**TOWN OF COVENTRY, RI
DEPARTMENT OF PLANNING & DEVELOPMENT**

STAFF REPORT

Project Name:	Proscape Landscaping
Project Type:	Development Plan Review
Plan Review Phase:	Amended Development Plan Review (Preliminary/Final Plan)
Applicant/Owner:	Backstreet Holdings
Address:	2043 Maple Root Road
Plat / Lot / Zone:	AP 10 Lot 40.11 Zone GB1 Lot Size 5.29 Acres
Existing Use:	Landscaping Business
Proposed Use:	Landscaping Business
Description:	The applicant proposes to amend its previously-approved Preliminary/Final Plan DPR application to relocate a stormwater retention basin and to extend a double-row of plantings along its shared property line with.

November 2023 (previously approved)

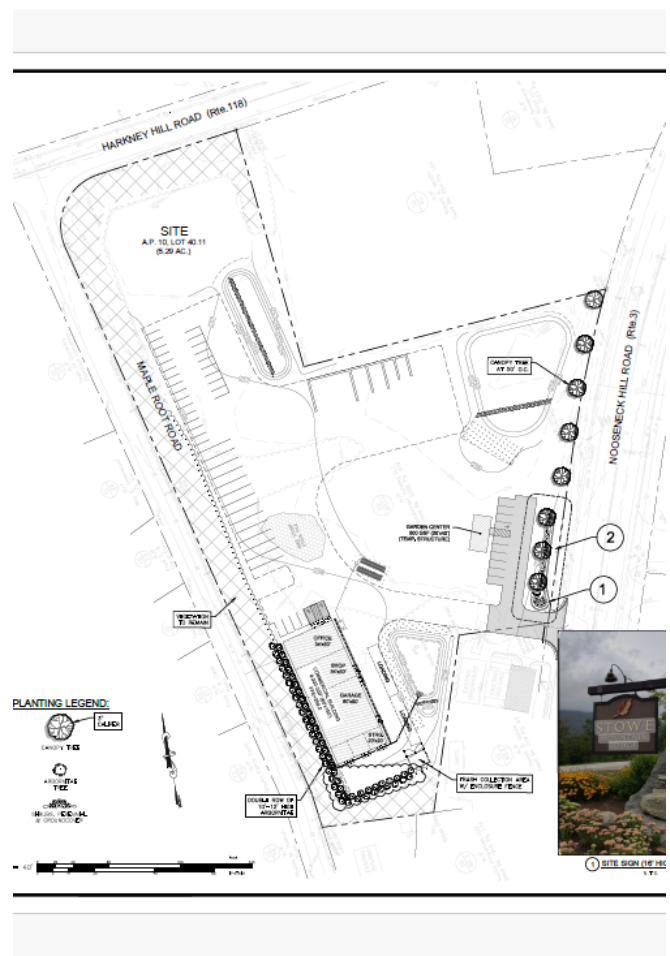
The applicant proposes to amend its record plan to relocate a drainage basin and to extend the double-row of arbor vitae plantings to screen the building along its shared property line with AP 10, Lot 40.12. The drainage basin relocation facilitates the applicant's ability to use that area of the site for staging; the extension of plantings was a request from Planning staff to ensure the residential abutter to the south would enjoy the same benefits of screening as the neighbors on the other side of Maple Root Road will.

The landscape plan excerpts below provide a convenient visual comparison of how the site layout would change as a result of the proposed amendment.

1. Consistent with the amended plans, the applicant shall provide a 10- to 12-foot high vegetated buffer comprised of “Green Giant” arborvitae trees, planted in a staggered double-row configuration, behind the 9,000 SF commercial building and paralleling the shared property line with AP 10, Lot 40.12 to ensure all residential abutters are adequately screened from the commercial development. These plantings shall occur no later than six months after the date of recording of this decision.
